Service Bulletin No. 93-1

Subject: Flap Flutter

Models Affected: Sequoia F.8L Falco (all aircraft built from plans and/or kits)

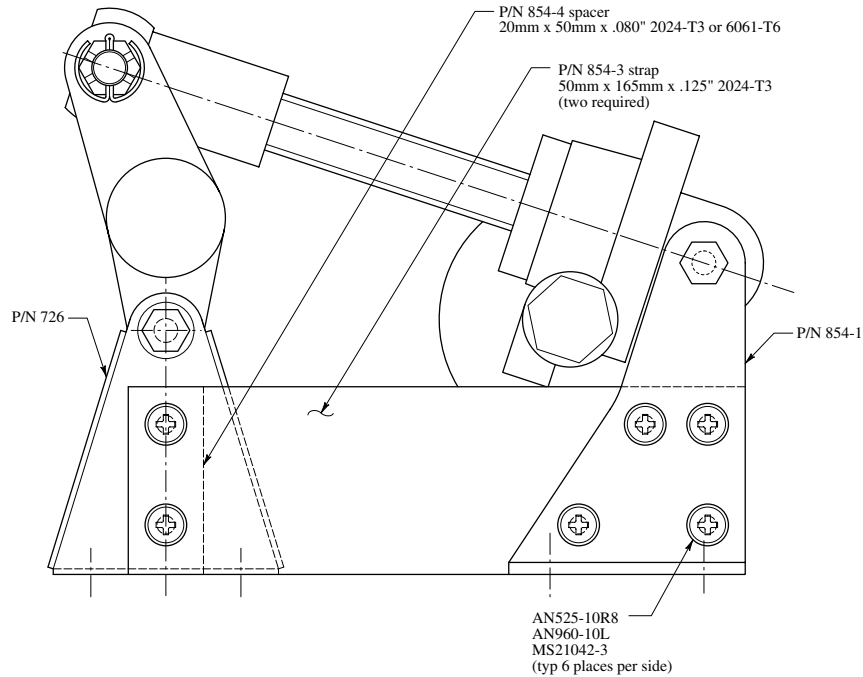
As an interim measure, the bolts on the aft end of the flap control pushrod can be tightened onto the spherical bearings and a substantial amount of free play can be eliminated. In addition, the

close tolerance bolts can be installed incrementally. It is quite easy to install the bolts on the outboard end of the flap control system.

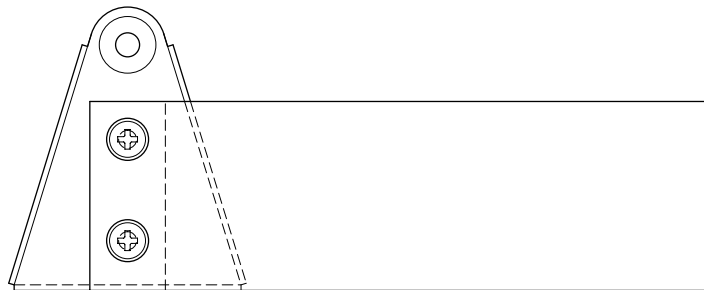
3. Install reinforcing straps between P/N 726 torque tube support and P/N 854-1 & -2 flap actuator support mounts as shown below.

To be sure, this installation is a difficult one. In order to accomplish this, you must first remove the actuator and torque tube. The torque tube does not have to be removed from the airplane, only from P/N 726.

Remove P/N 726 from the aircraft and install P/N 854-4 spacers and P/N 854-3 straps on each side. In order to do this, you must grind the turned out flange of P/N 725 down to a height of 2mm (.080"). Install the straps with the screws. When you drill the holes for the screws, clamp the components to a flat table so that the bottoms of the parts will be aligned. The screws should be located about 10mm (or 3/8") from the edge of the parts. Note that there is very little space in the middle of P/N 726, thus you must first slide the nuts and washers in place, and then install the screws.

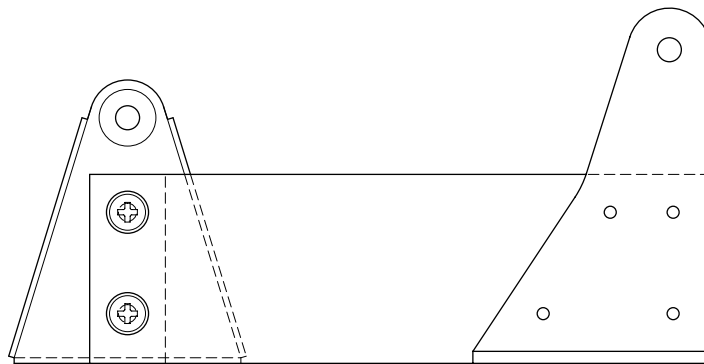
Drill four 1/8" holes in the actuator support brackets as shown above. Again, these holes should be located about 10mm from the edge of the parts.

Put the components back in the airplane and tighten up the nuts on the screws which hold them in the bottom of the aircraft. The straps on the outside of P/N 726 should go on the inside of the actuator support brackets.

With an angle drill with a 1/8" drill in the actuator support brackets to drill through the P/N 854-3 straps. As you drill each hole, put a cleco in the hole.

When all holes are drilled, remove this from the aircraft. By removing one cleco at a time, ream up the screw holes and install the four screws between the actuator supports and the straps.
